TERAVALIS PHASE 1 SOILS CEMENT & RIPRAP INFRASTRUCTURE CFD

ADDENDUM NUMBER: 02

SOIL CEMENT AND RIPRAP

TERAVALIS PHASE 1 SOIL CEMENT & RIPRAP INFRASTRUCTURE CFD

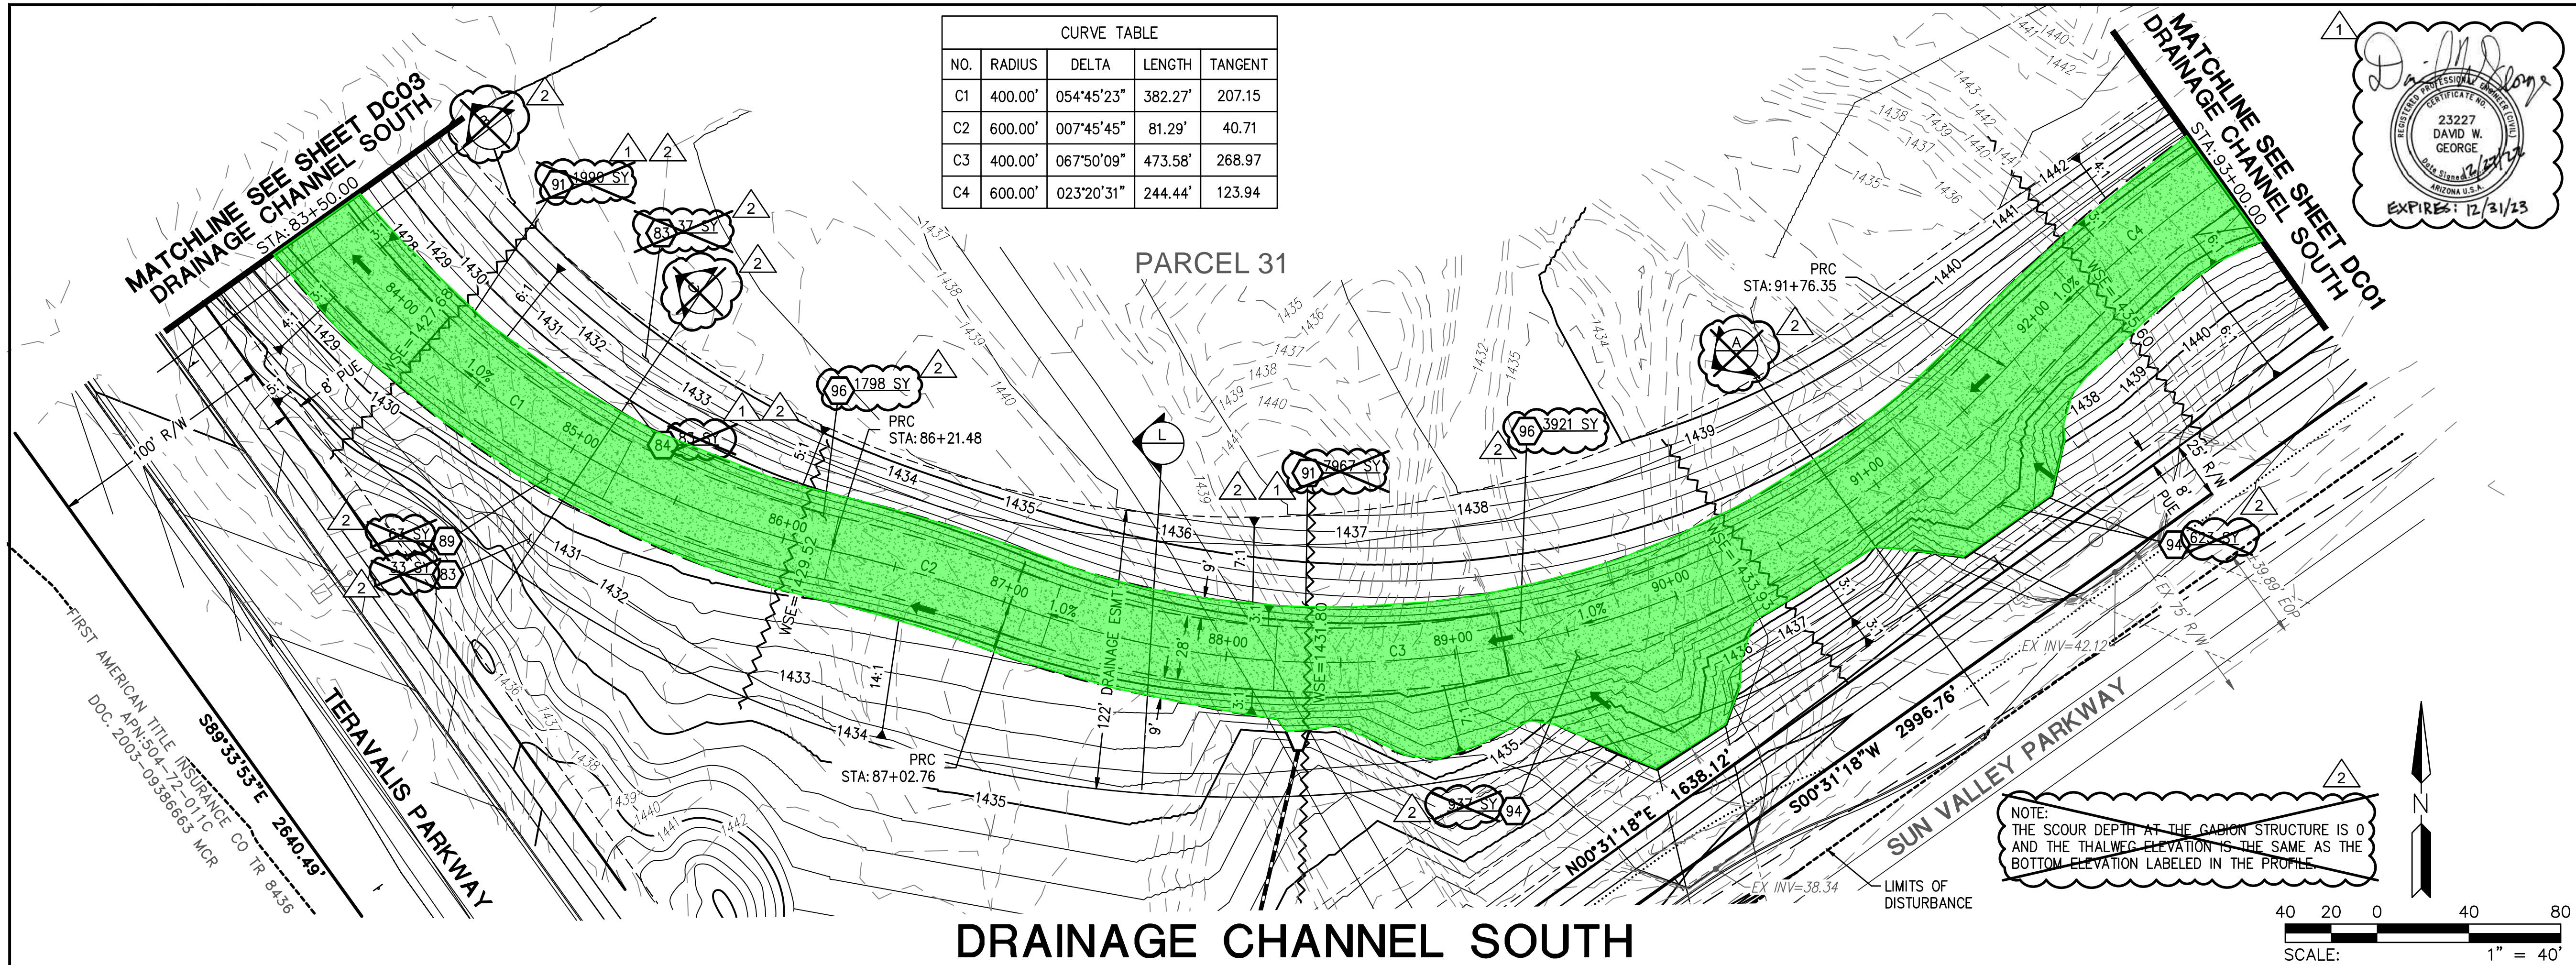
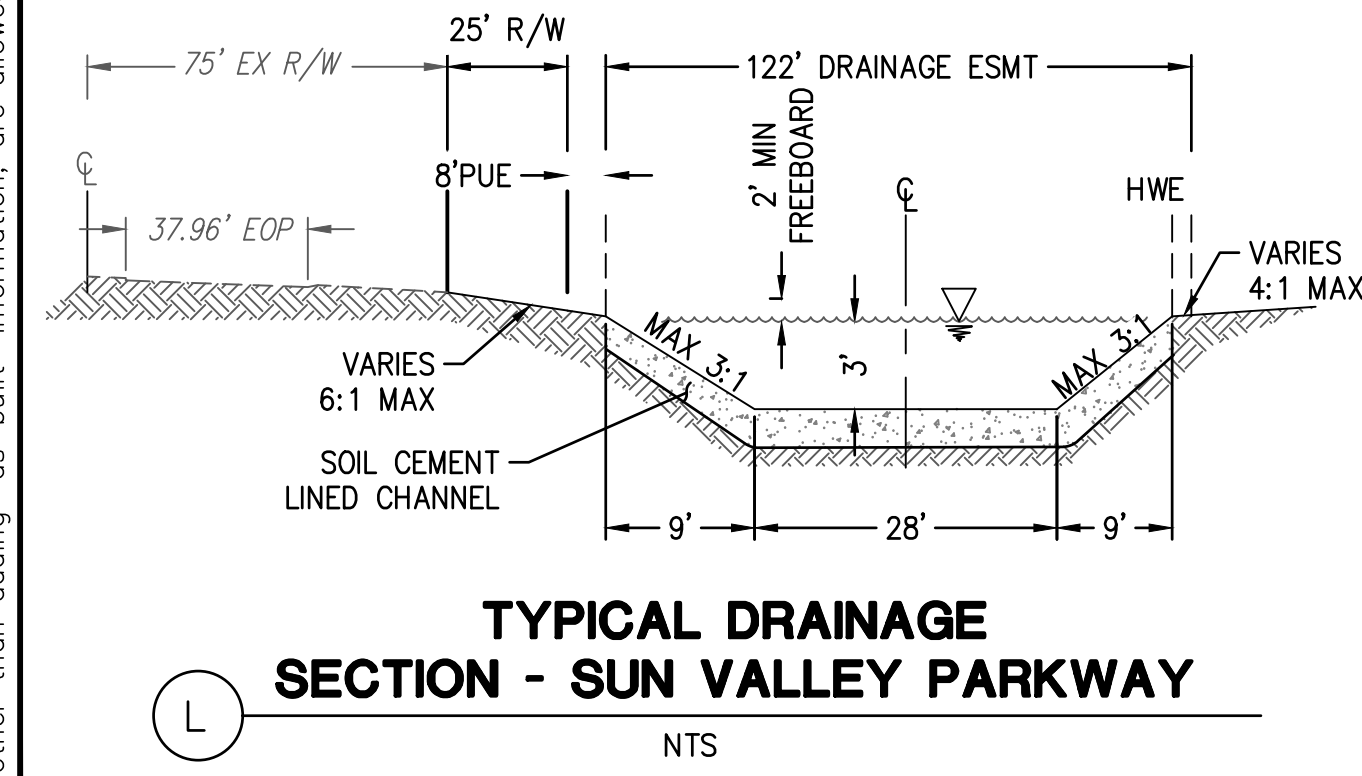
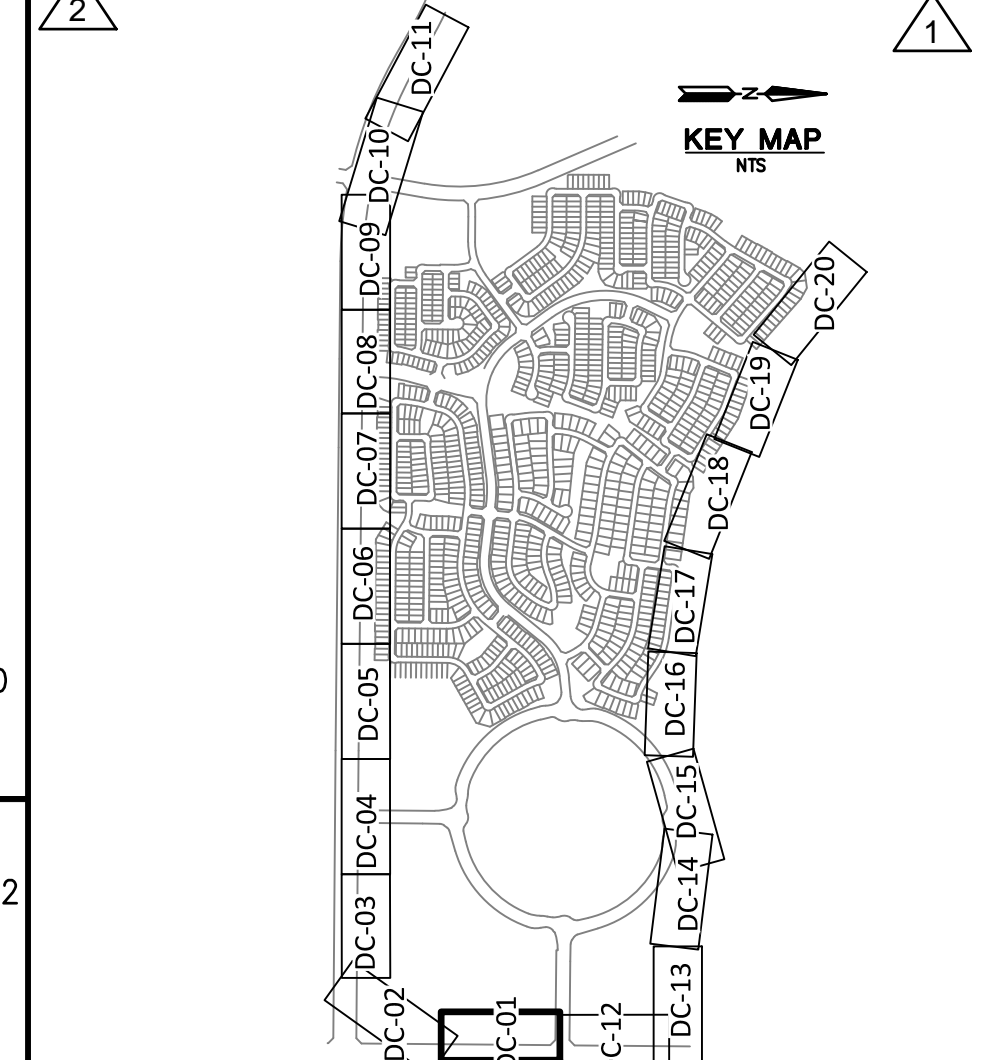
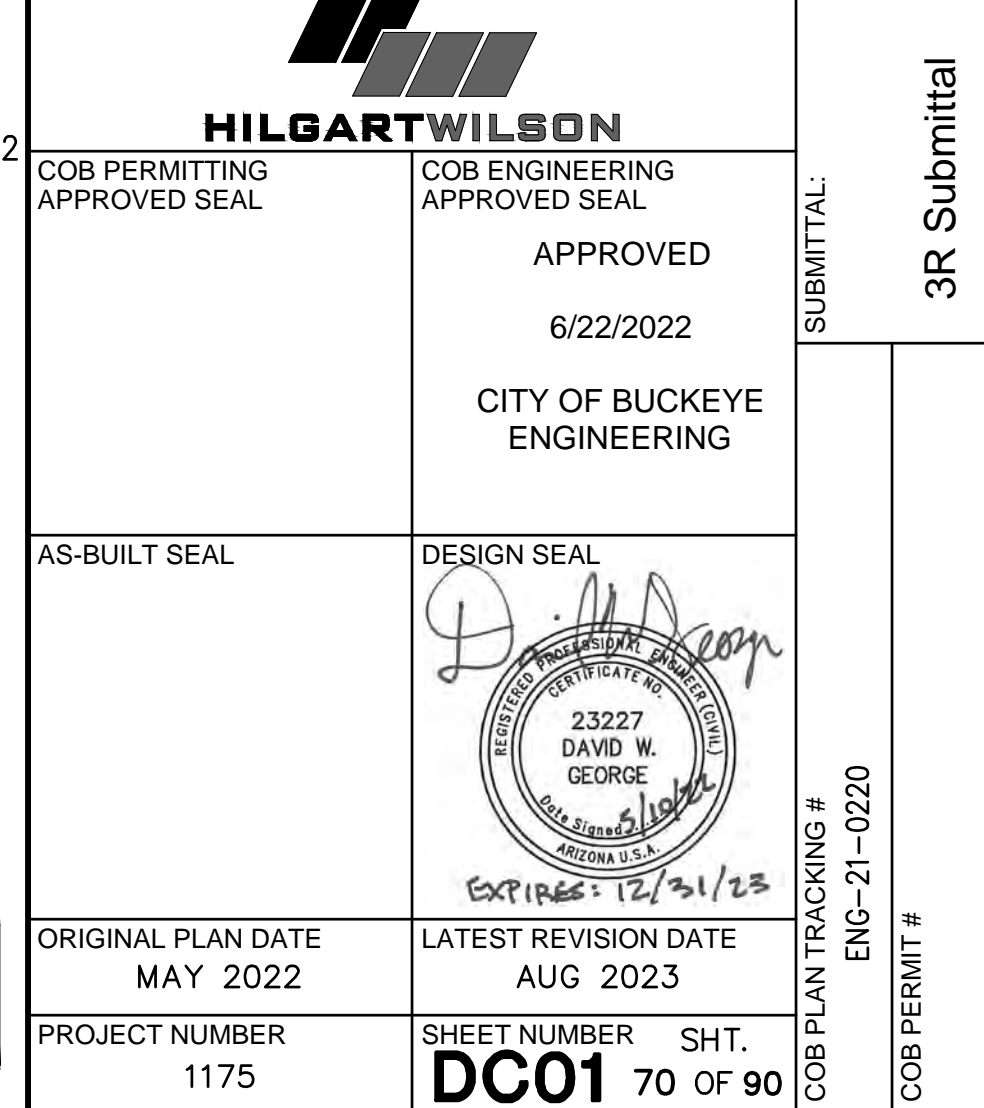
- a. Sheet DC01 - Added station and offset at the start and end of the soil cement. for construction of the access road see Floreo at Teravalis.
 - b. Sheet DC10 – Added to show stations to show start and end of soil cement for access road.
